SUNDRY NOTICES AND REPORTS ON WELLS

8. FARM OR LEASE NAME
Northeast Haynes

9. WELL NO.
15

Attachment to Notice of
Intention to Abandon

~Proposed P&A~

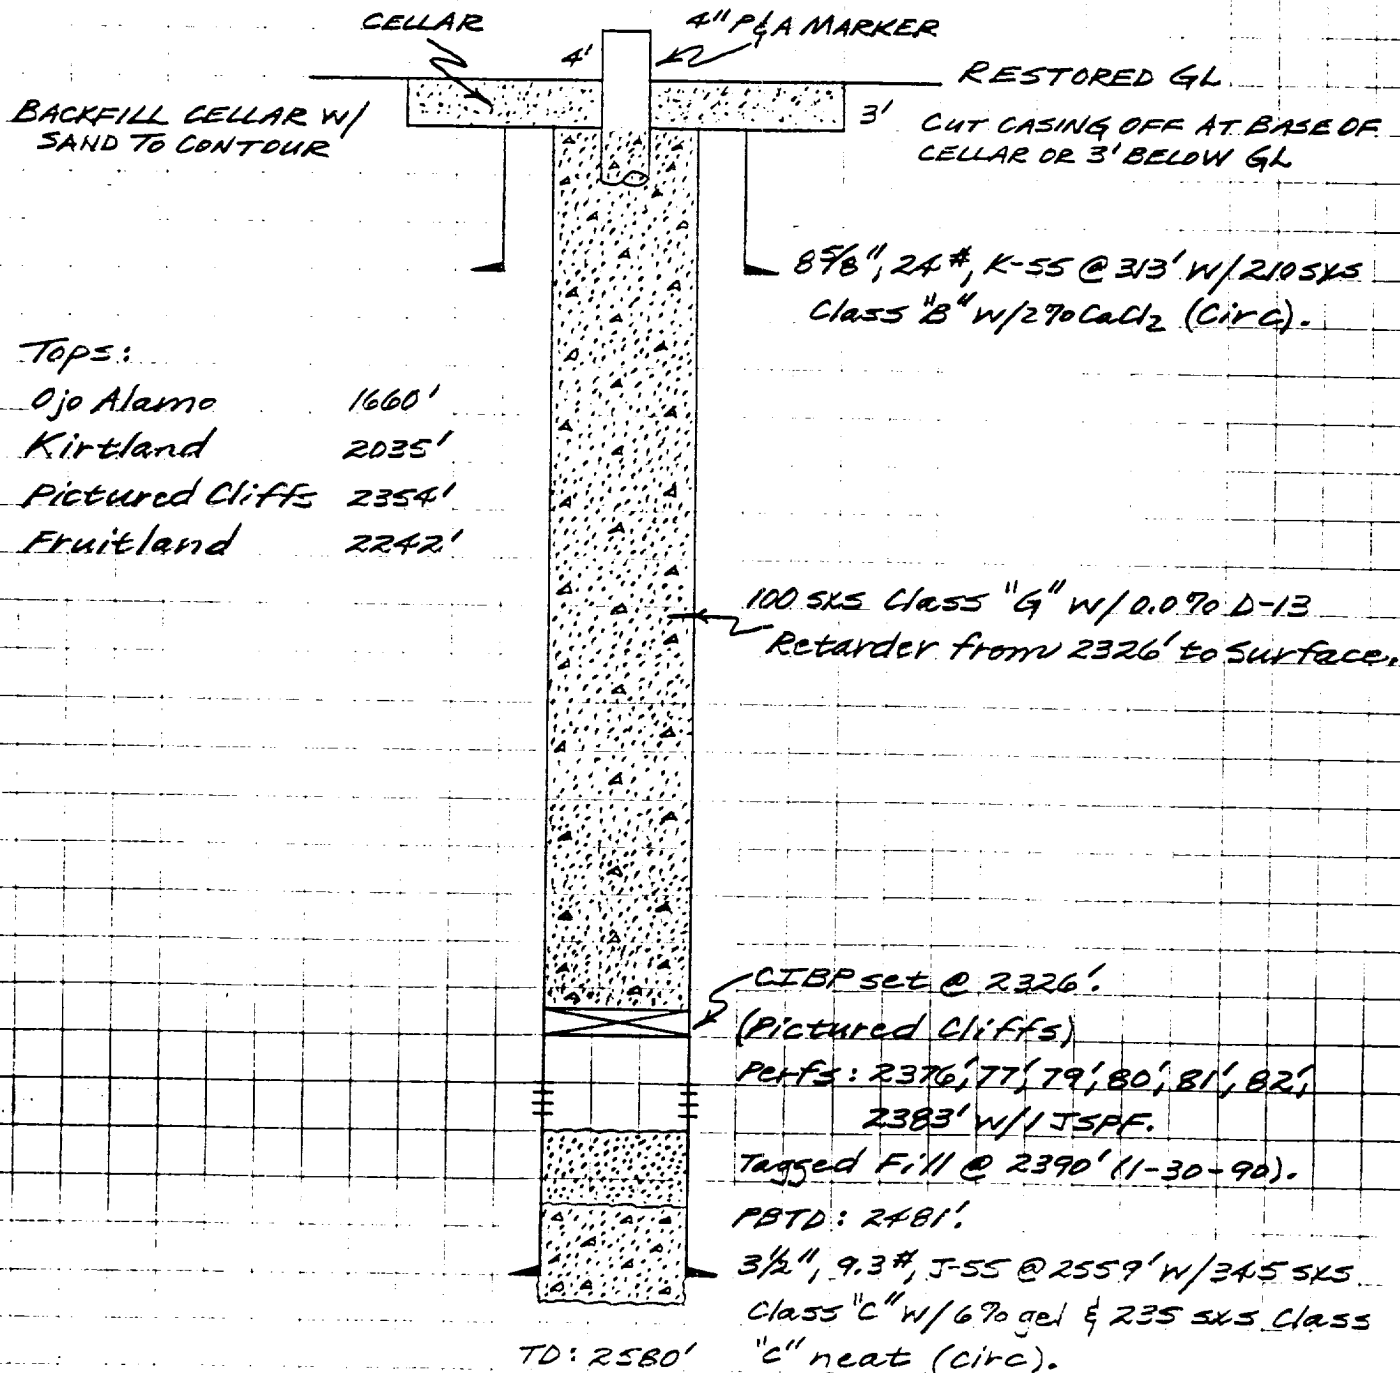
1. Plugging operations authorized are subject to the attached "General Requirements for Permanent Abandonment of Wells on Federal Leases."
2. Mark Kelly with the Farmington Office is to be notified at least 24 hours before the plugging operations commence (505) ~~327-5344~~. 326-6201
3. Blowout prevention equipment is required.
4. The following modifications to your plugging program are to be made (when applicable):
